## II. **Assam State Zoo, Guwahati, Assam**

### 1. Revised designs of Pigmy hog enclosure

Proposed Enclosure Detail for  
Sri.Chamarajendra Zoological Garder  
at Mysore

LAYOUT PLAN FOR LEOPARD AND LION ENCLOSURES

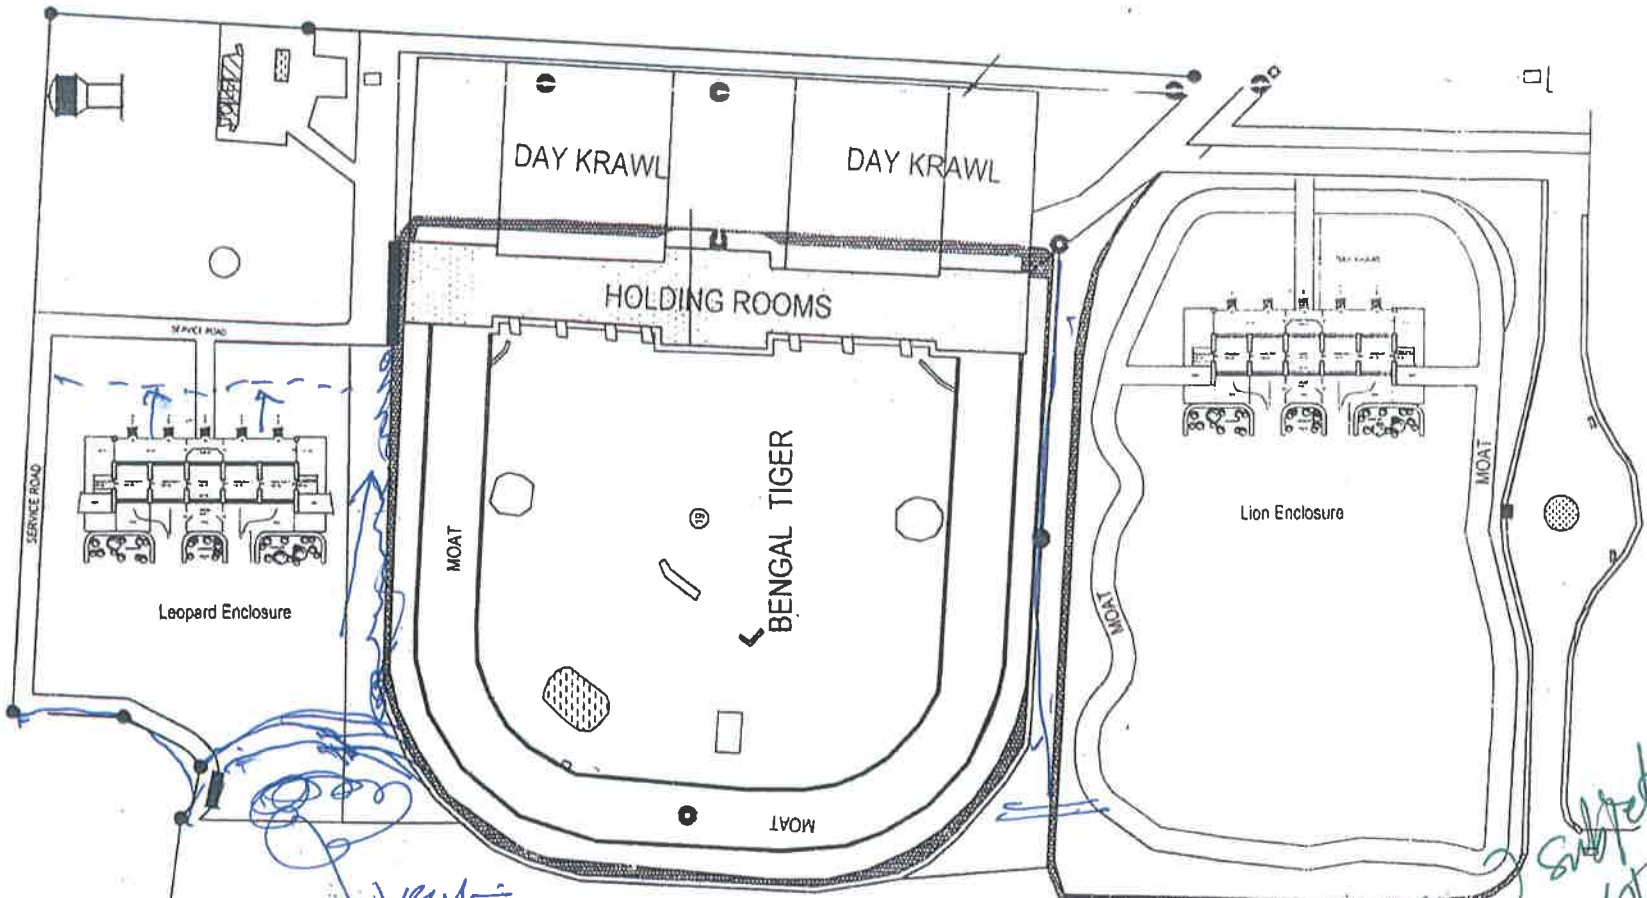
The design was scrutinized and approved.
